DOVER SCHOOL DISTRICT	JOINT BUILDING COMMITTEE – DOVER HIGH SCHOOL AND REGIONAL CTC MEETING NOTICE	
	Meeting Type:	**Regular Meeting**
	Meeting Location:	**Superintendent's Conference Rm, McConnell Center**
	Meeting Date:	**Tuesday, July 23, 2019**
	Meeting Time:	**4:30 P.M.**

Joint Building Committee
Dover High School and Regional CTC
Minutes

Re: Change Request Proposal – 190305
Auto Collision Wash Bay

Re: Change Request Proposal – 190361
Softball Fields Fence Revisions

DRAWING NUMBER
SKE 78
JOB NUMBER 403114

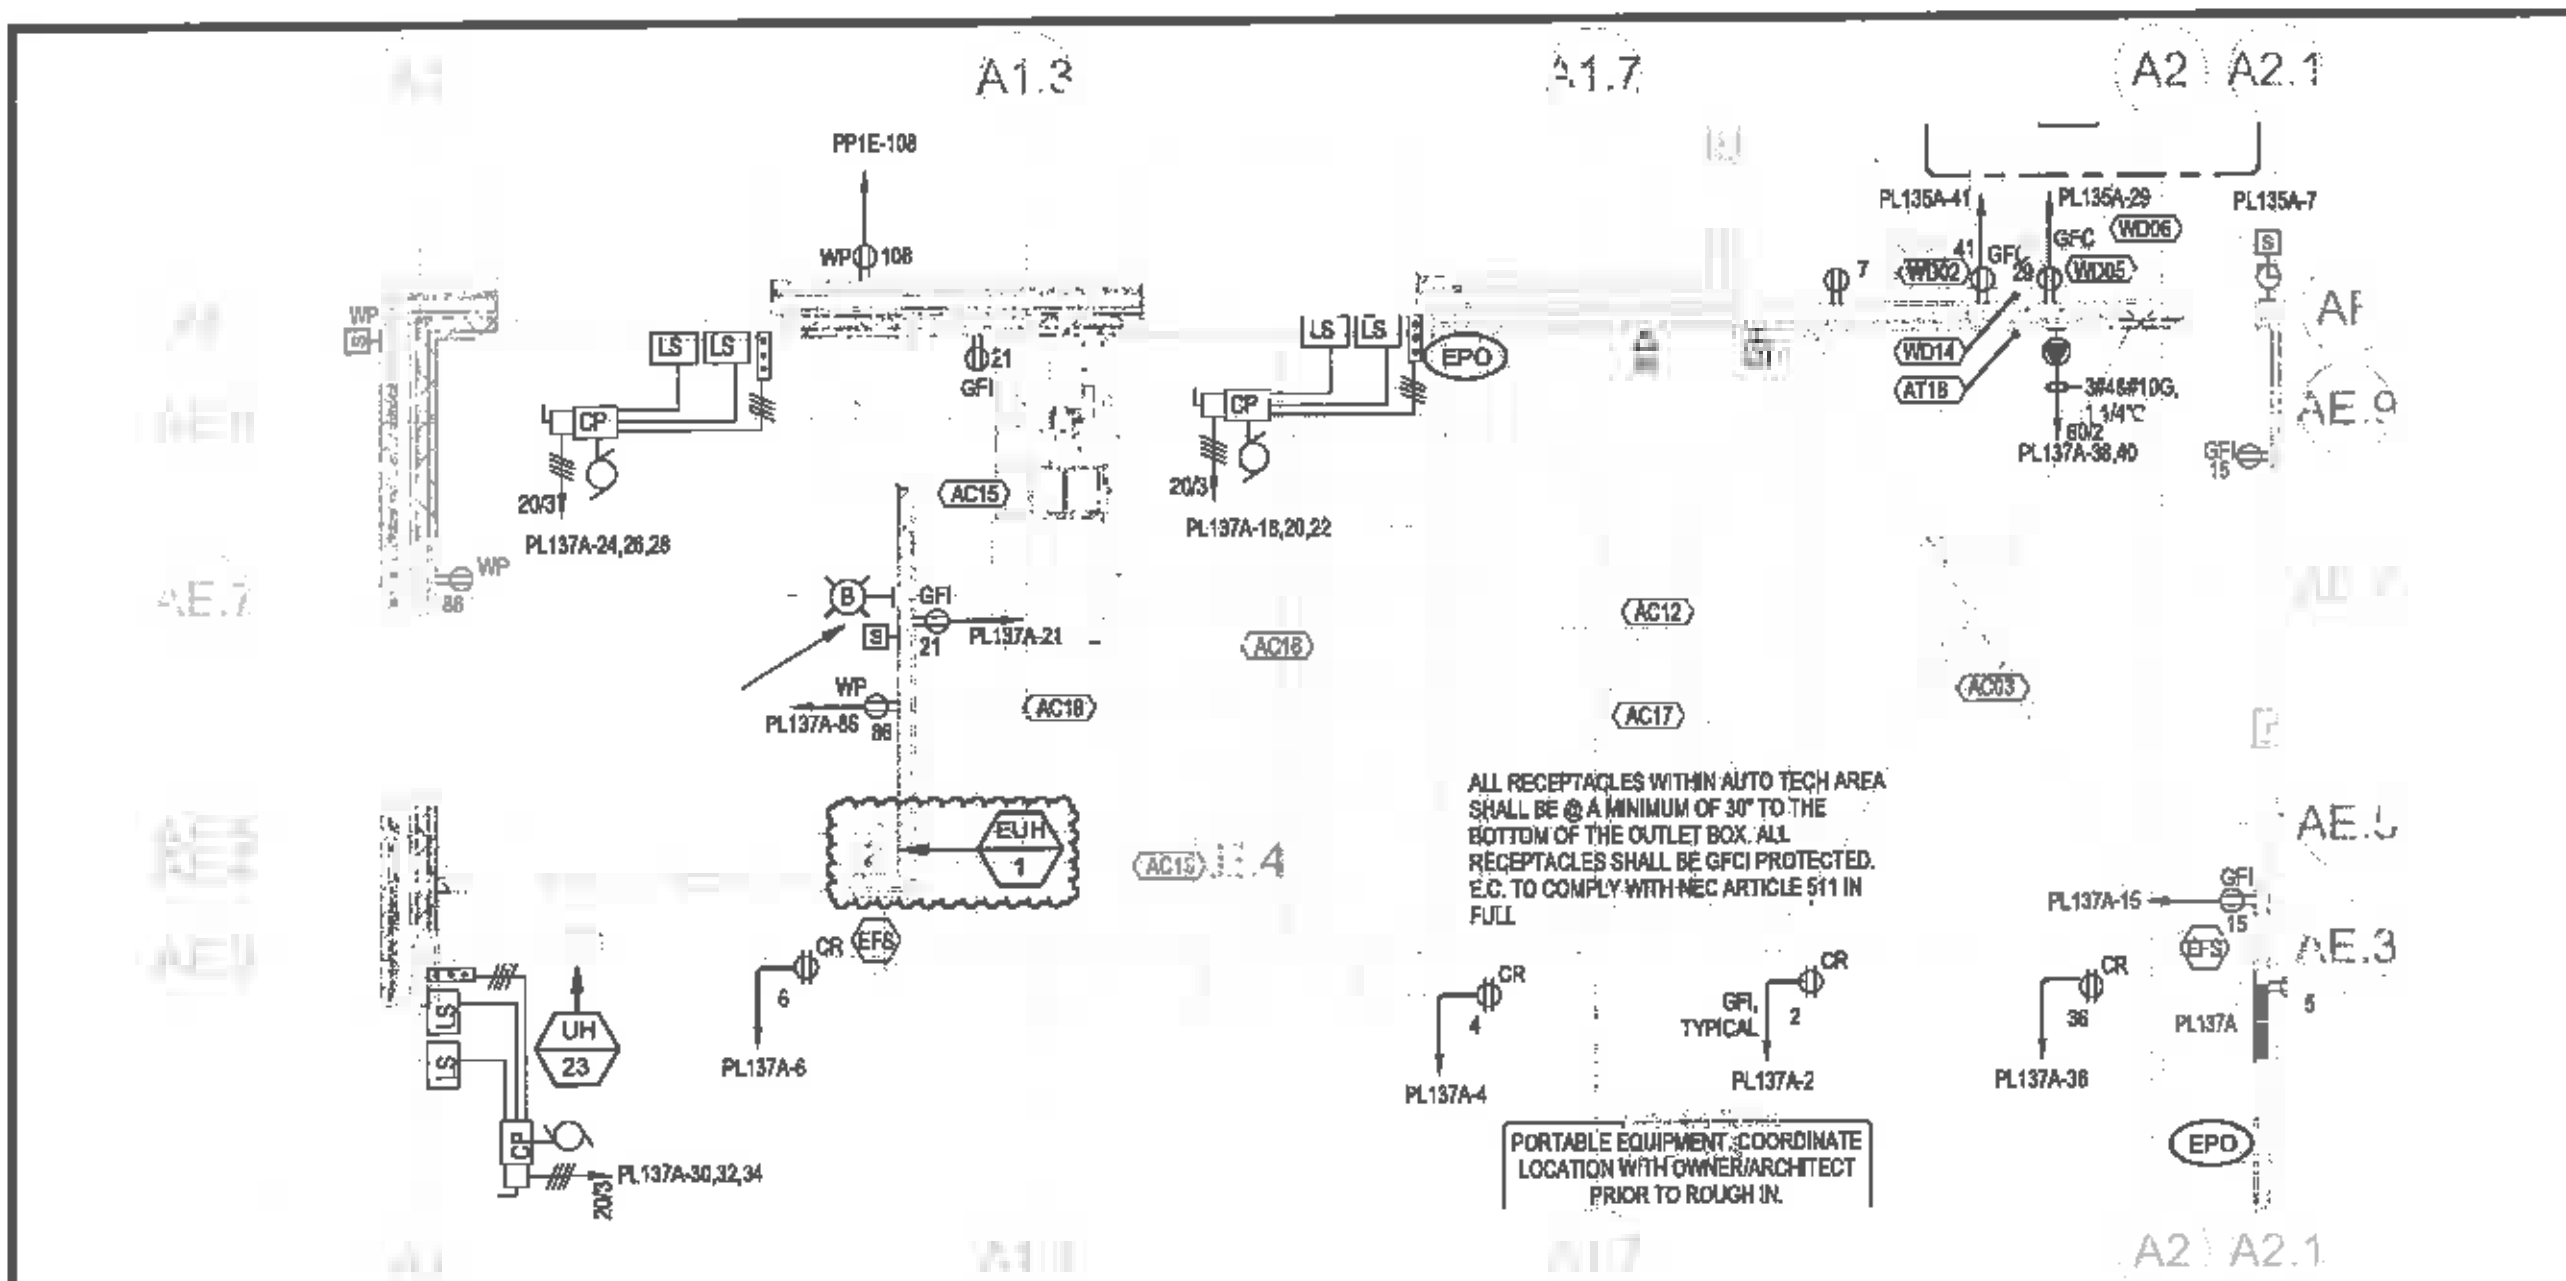
Scope Of Work
Request to change/add the following at the Auto Collision Wash Bay:
1. Electric unit heater to be installed inside wash bay and will be controlled by a thermostat mounted on the wall.
2. 4.5kW electric water heater to be installed on top of the wash bay roof.
3. Compressed air line to be installed to wash bay.
4. Hot water line to be installed to wash bay with spigot.
5. Replace light switches.
6. Remove occupancy sensor and daylight sensor.
7. Replace speaker/strobe with weatherproof speaker/strobe.
8. Superintendent time for coordination of work, safety supervision and inspections required.
9. Estimating time for additional pricing due to five design changes in scope.
revised to remove controls scope, this will be a locally controlled system

Dover HS / CTC
Dover, NH
ADDED ELECTRIC UNIT HEATER IN WASH BAY

SKE 77

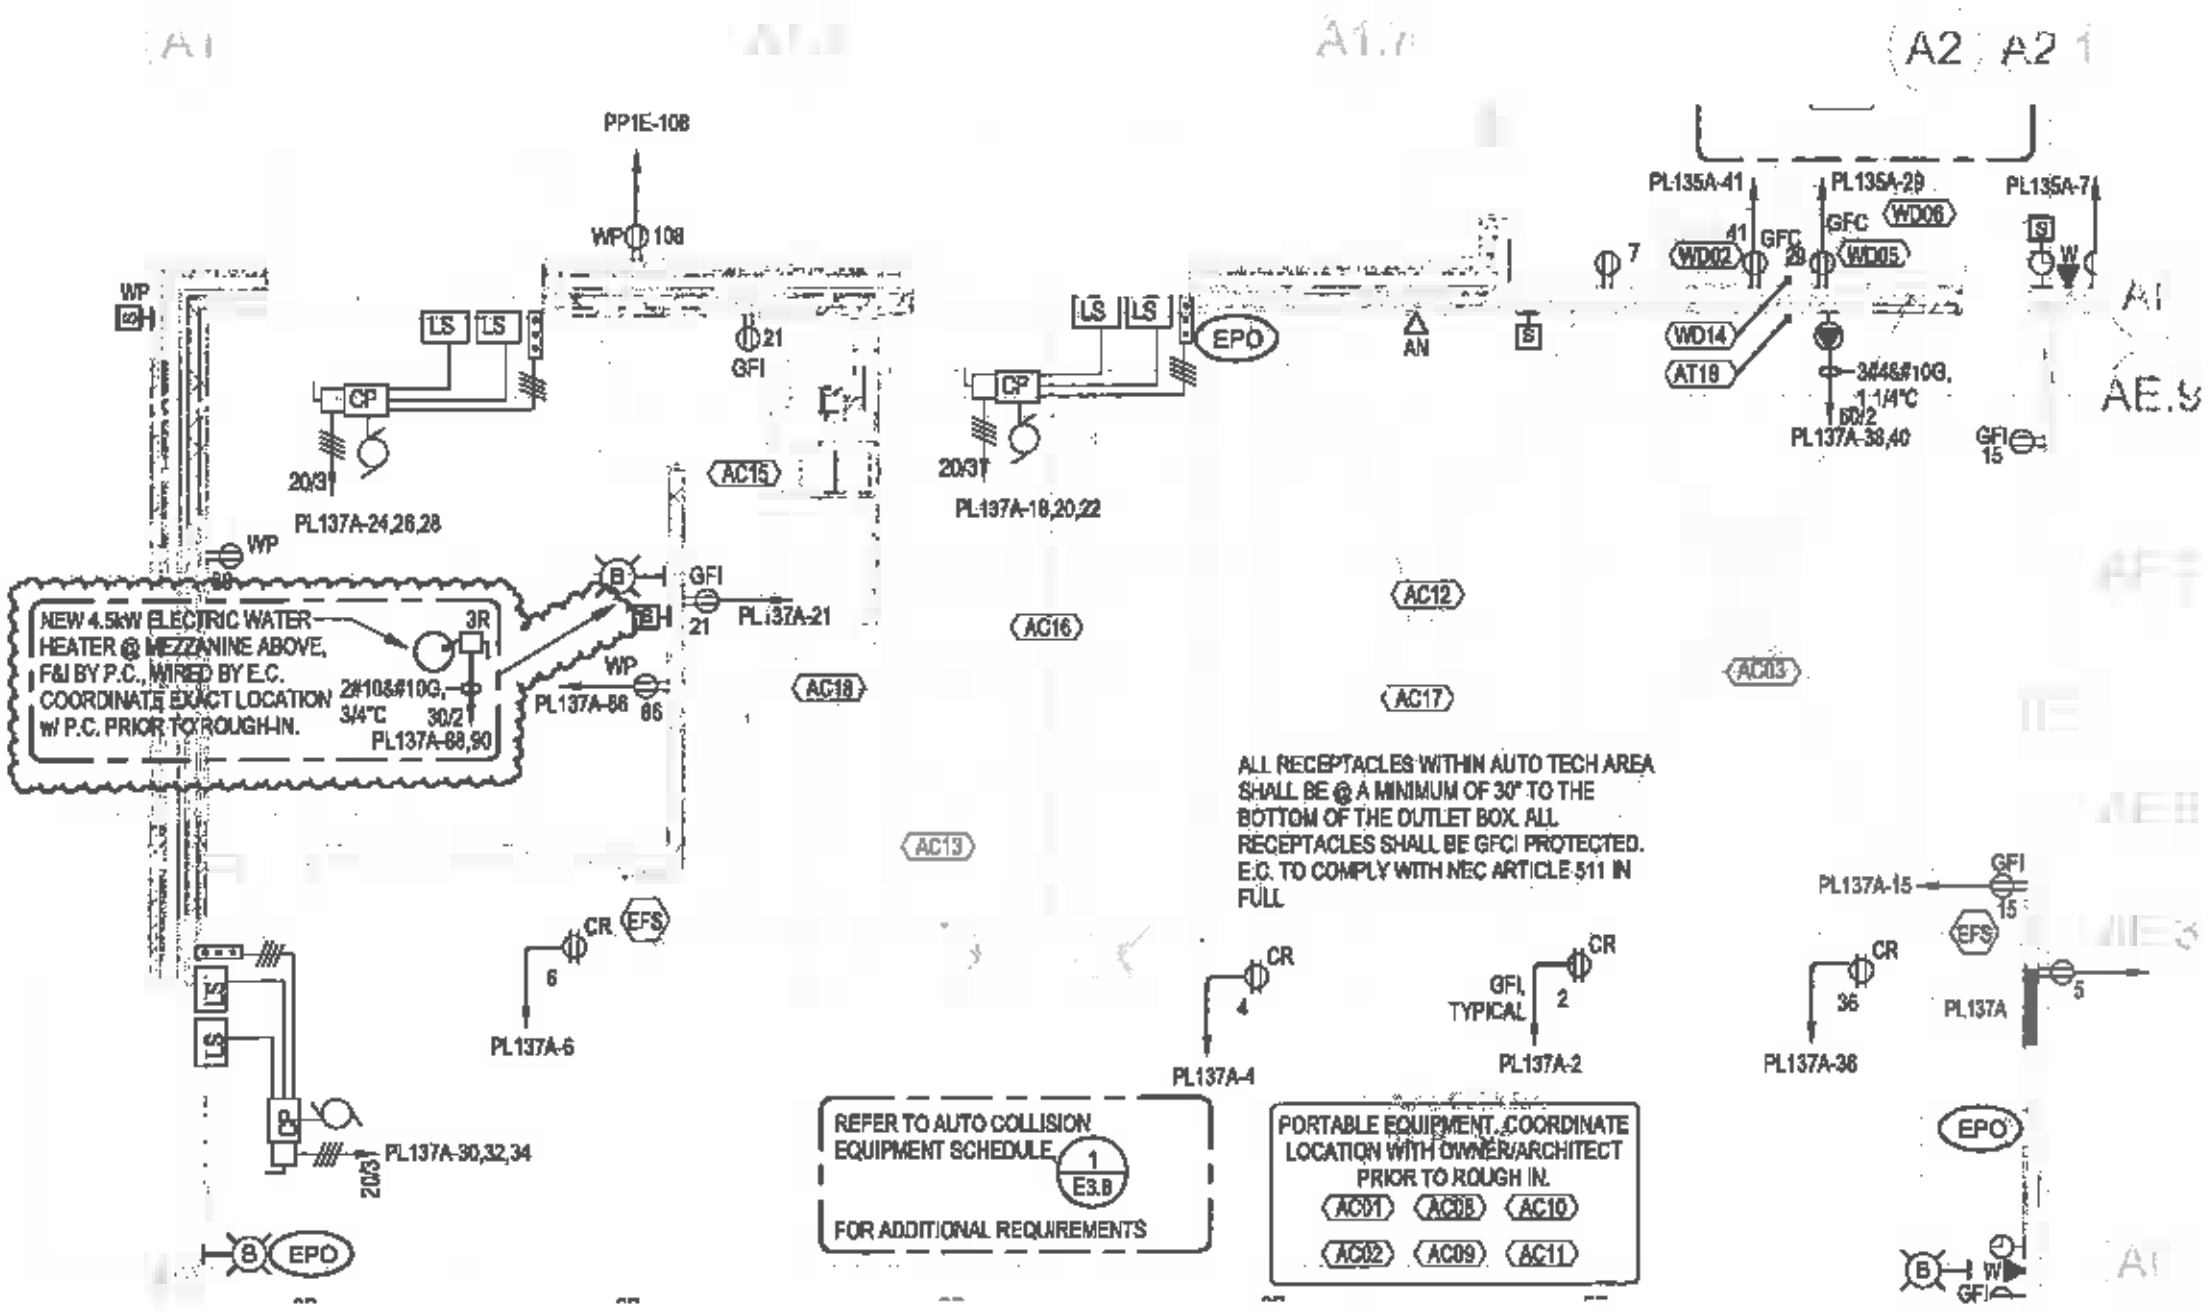
ADDED ELECTRIC WATER HEATER IN AUTO COLLISION 137A TO SERVE WASH BAY

DRAWING NUMBER
SKL
013
JOB NUMBER

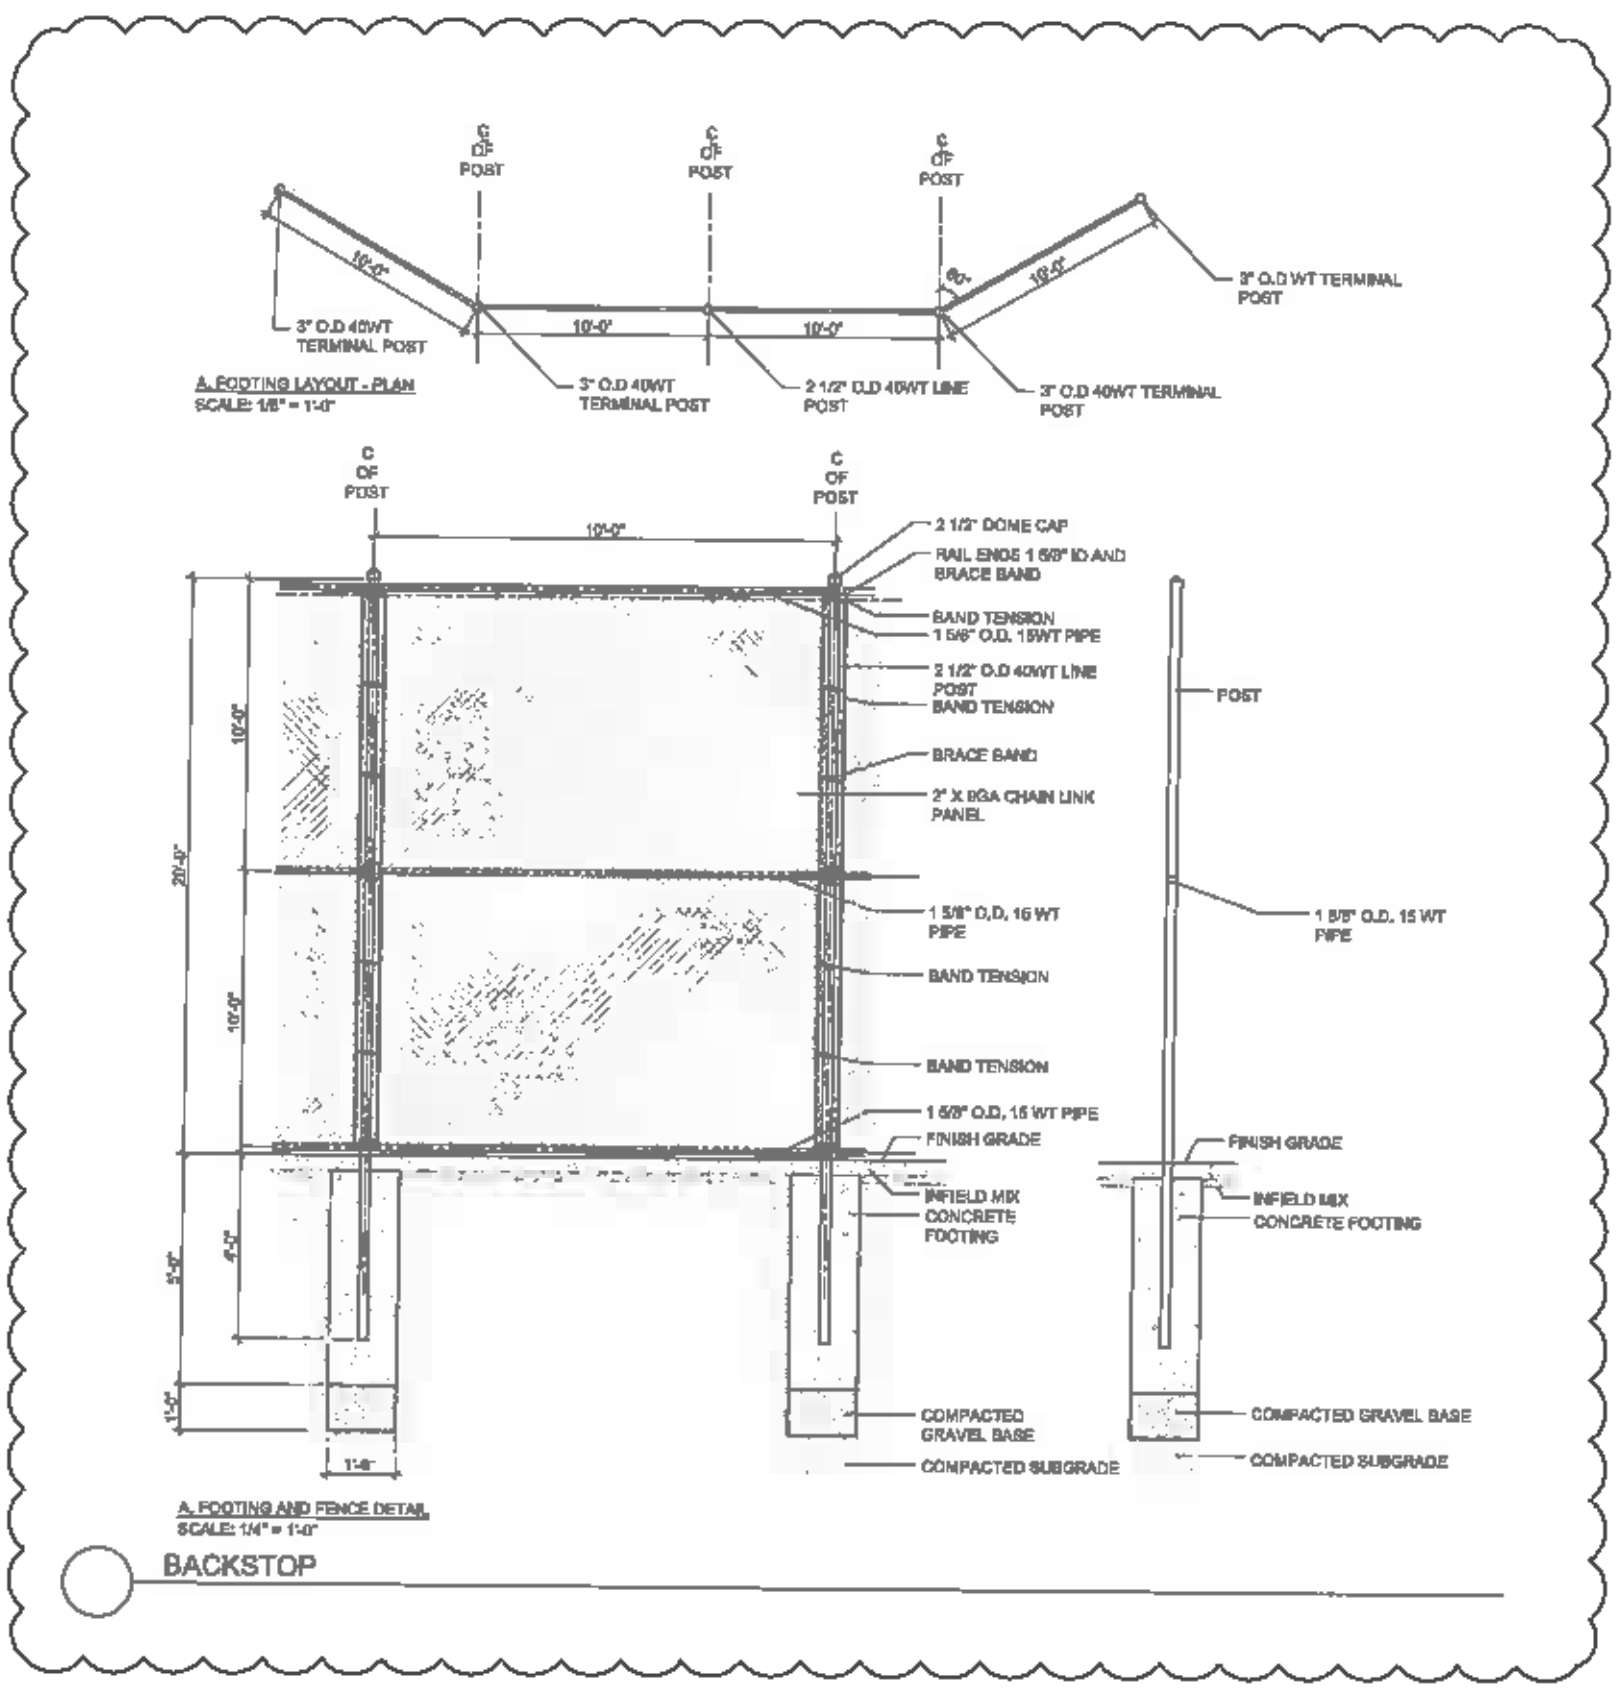
Scope Of Work
Proposal to shift the softball fields as shown in PR-67. Cost includes additional sidewalk to the fields, change in backstops and fencing and coordination with subcontractors due to re-design of the fields after pre-construction meetings/submittal reviews.

BACKSTOP DETAIL REVISION
(DETAIL 1/L4.10)
